Access Compliance Report

Public Rights-of-Way

(Curb Ramps)

Intersection ID: 49183	Main Street: ST_JOHN_LN	Cross Street: ST_STEPHEN_LN	Location: NE
ADA ID: CDB6437FA390	Ramp Type: Perp	Initial Pass/Fail: Pass	Overall Compliance: No
Severity Score: 22.5			
Codes/Mitigation Info/Possible Solution		Field Measurements/Component Compliance

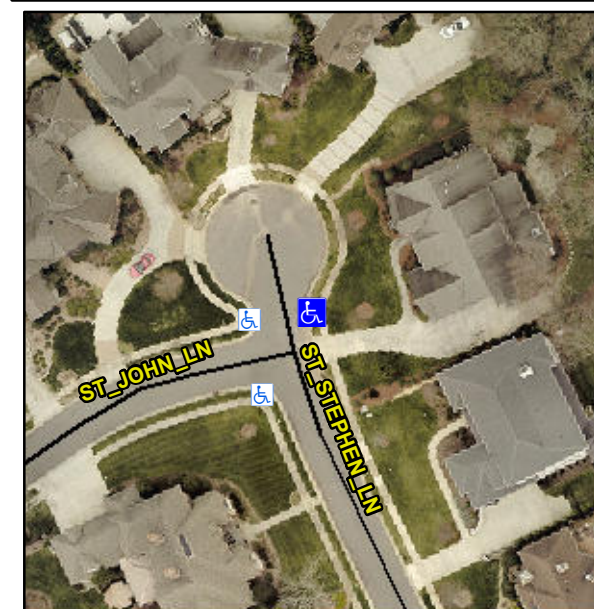
**Remove & Replace Entire Ramp.
Remove & Replace Gutter.**

**R304.2.1, R304.5.3, R305.1.4, R305.2,
R302.7.2, R304.5.4**
